CERTIFICATE OF APPROPRIATENESS

Property: 5003 Mandell Street, Lot 2, Block 1, Edgemont Subdivision. The property includes a historic 2,889 square foot, two-story wood frame single-family residence and a detached garage situated on a 5,000 square foot (50' x 100') interior lot.

Proposal: Alteration – Replace two historic windows on the second floor of the south side elevation.

Recommendation: Denial - does not satisfy criteria

WINDOWS 4 AND 5

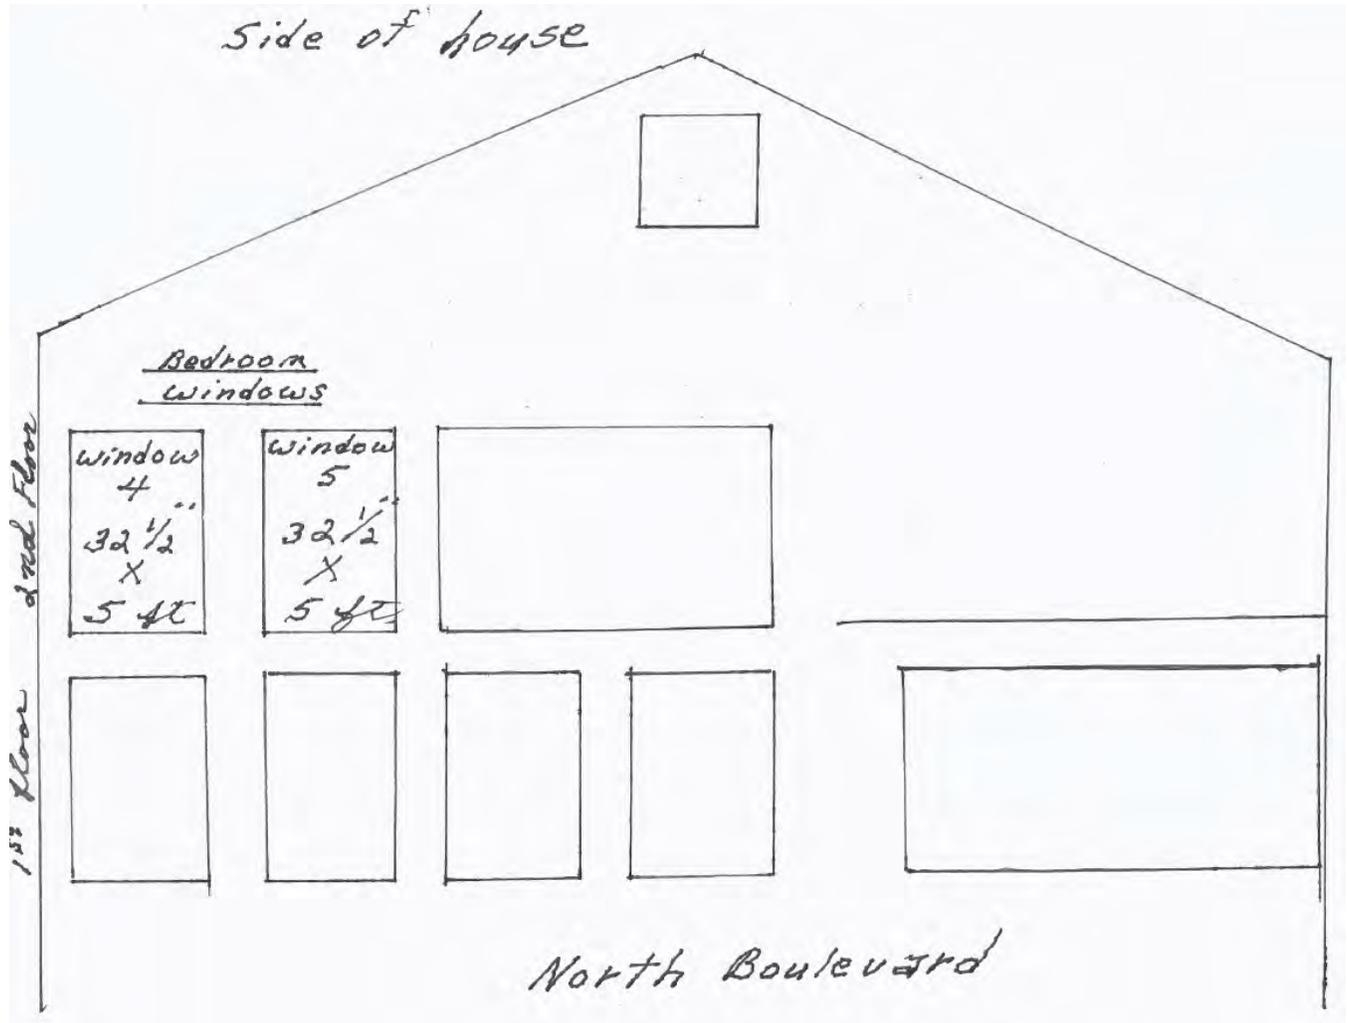
<i>Historic wood windows are an irreplaceable distinguishing quality of this structure, and other Contributing structures found throughout the Boulevard Oaks Historic District. Window 4 features lower sash deterioration but can be repaired, by replacing the damaged portion of the sash. Window 5 is not damaged. Removing these windows represents a failure to maintain the structure's distinguishing qualities.</i> |

<i>Replacing repairable windows with a pair of new windows represents a destruction of significant historical and architectural material.</i> |

WINDOW 4

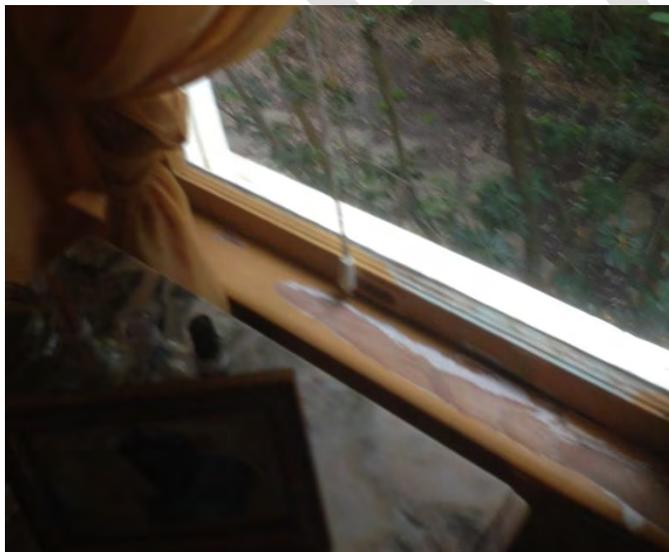
Window 4 features a heavily deteriorated bottom rail on the lower sash. The rail is saturated with water to the point where it is soft and damp to the touch. The remainder of the window's components appear to be in good condition. The window is painted shut.

STAFF PHOTOS
WINDOW 5

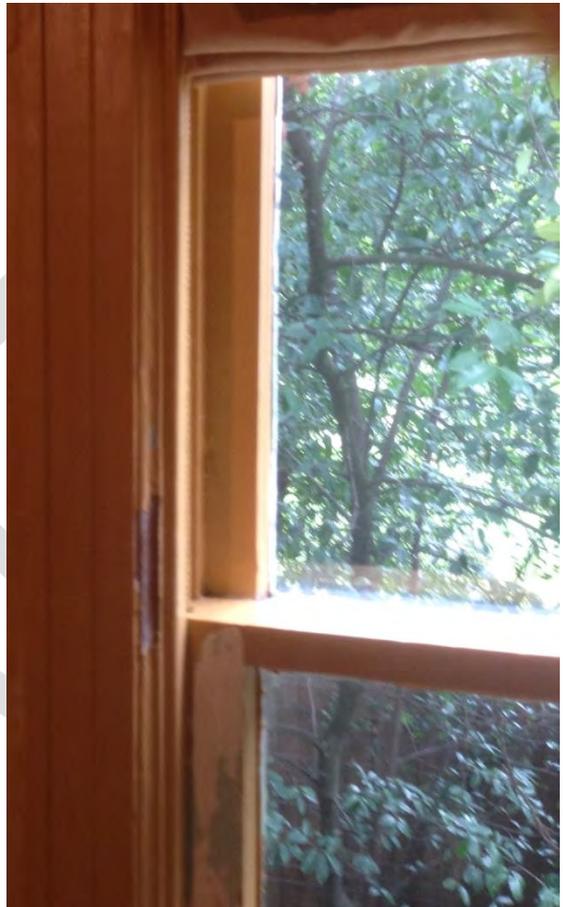
Window 5 appears to be in good condition. The window is painted shut.
